ALERT SERVICE BULLETIN

UH-1H-13-11  
4 November 2013

**MODEL AFFECTED:** UH-1H

**SUBJECT:** ASSIGNMENT OF A 3,300 HOUR RETIREMENT LIFE AND RE-IDENTIFICATION OF ELEVATOR ASSEMBLIES P/N 205-030-856-157 AND -159 INSTALLED ON THE UH-1H HELICOPTER

## MODIFICATION PLATE FABRICATION

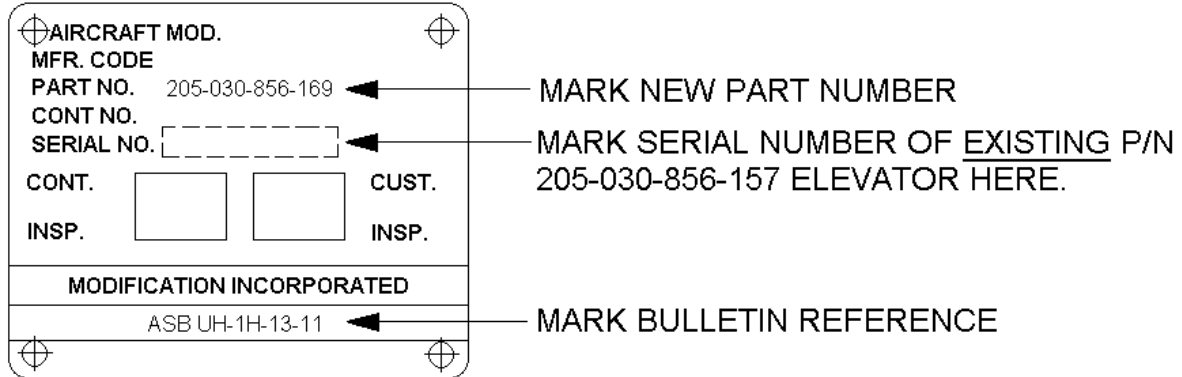
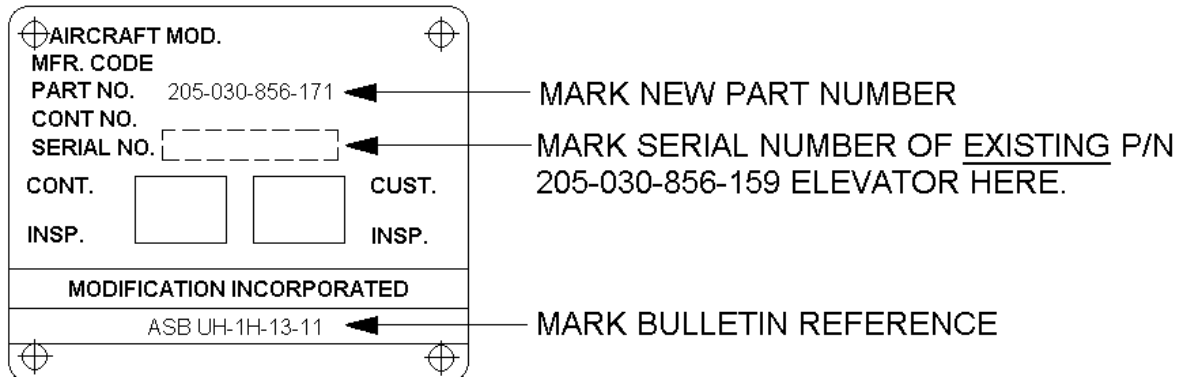
- a. Use a vibrating stylus, place a single scribed line through the entire existing part number on the manufacturer's data plate. **DO NOT OBLITERATE THE PART NUMBER AND DO NOT CHANGE OR ALTER THE SERIAL NUMBER.**
- b. Populate a P/N MS27253-1 modification plate as shown in Figure 1. Existing P/N 205-030-856-157/-159 elevator serial numbers shall not be changed or altered.
- c. Install the modification plate on the appropriate elevator assembly as shown in Figure 2. **Do not remove the existing manufacturer's data plate.**

NOTE: MARK MS27253-1 MODIFICATION PLATE USING IMPRESSION STAMP, DOT PEEN, OR VIBROSCRIBE ONLY.

### FOR P/N 205-030-856-157 ELEVATORS

### FOR P/N 205-030-856-159 ELEVATORS

**FIGURE 2**

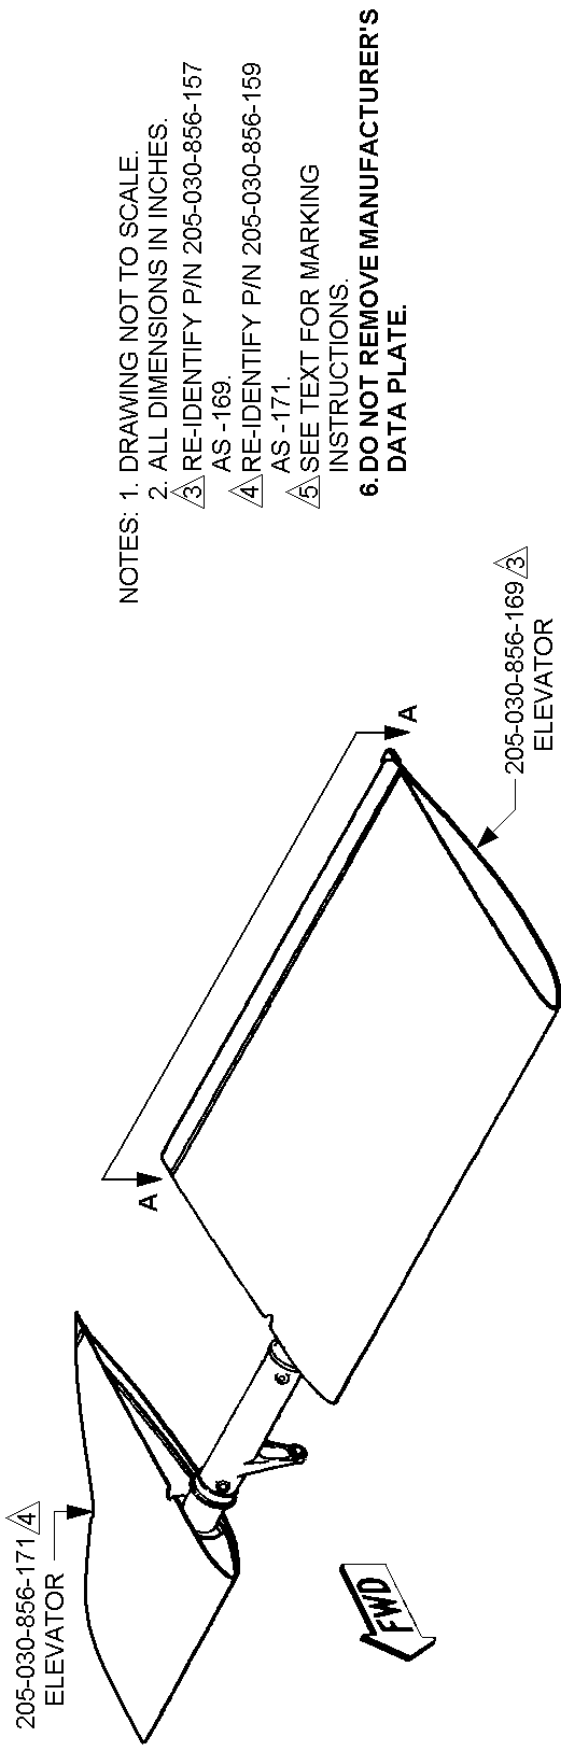
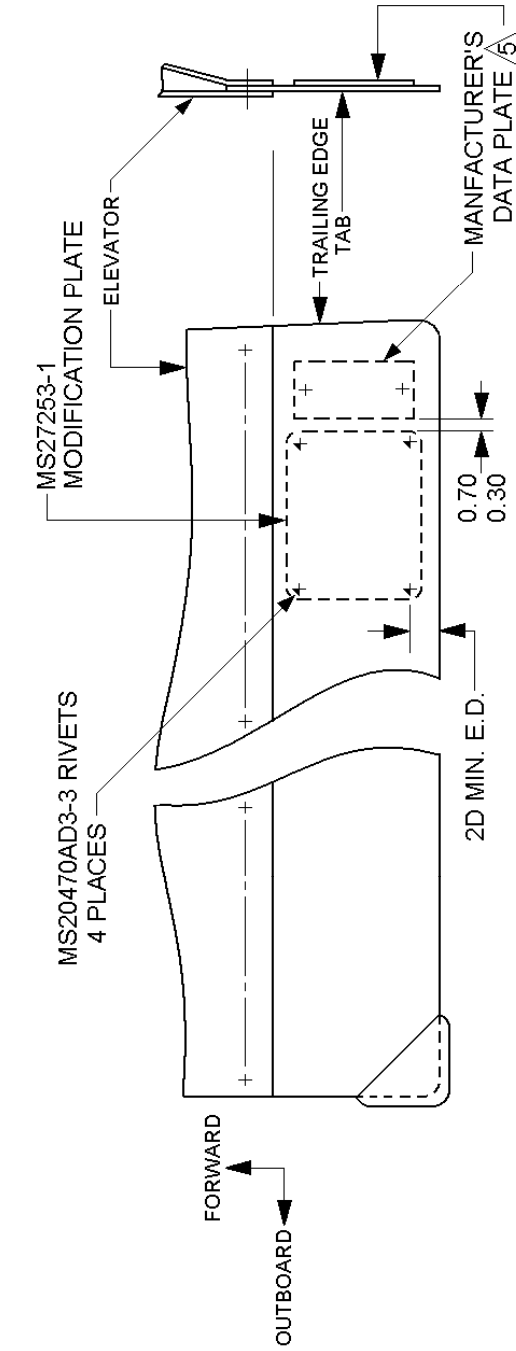
- 1) Locate the modification plate and back drill four fastener holes in the elevator tab. Use care to not bend the tab.
  - 2) Remove the modification plate and deburr holes in the elevator tab.
  - 3) Install each modification plate with four (4) MS20470AD3-3 rivets. Install fasteners with wet primer. Remove excess primer.
  - 4) Touch up primer and paint on the elevator tab as required.
- d. For each elevator modified, create a new historical record card (HRC) using:
- (1) The new part number, original elevator assembly serial number from the manufacturer's data plate, elevator total flight hours from the original HRC, and indicate the retirement life as 3,300 hours.
  - (2) Note elevator has been modified in accordance with this ASB.
  - (3) Update all other helicopter records as required.

- NOTES: 1. DRAWING NOT TO SCALE.  
 2. ALL DIMENSIONS IN INCHES.  
 3. RE-IDENTIFY P/N 205-030-856-157 AS -169.  
 4. RE-IDENTIFY P/N 205-030-856-159 AS -171.  
 5. SEE TEXT FOR MARKING INSTRUCTIONS.  
 6. DO NOT REMOVE MANUFACTURER'S DATA PLATE.
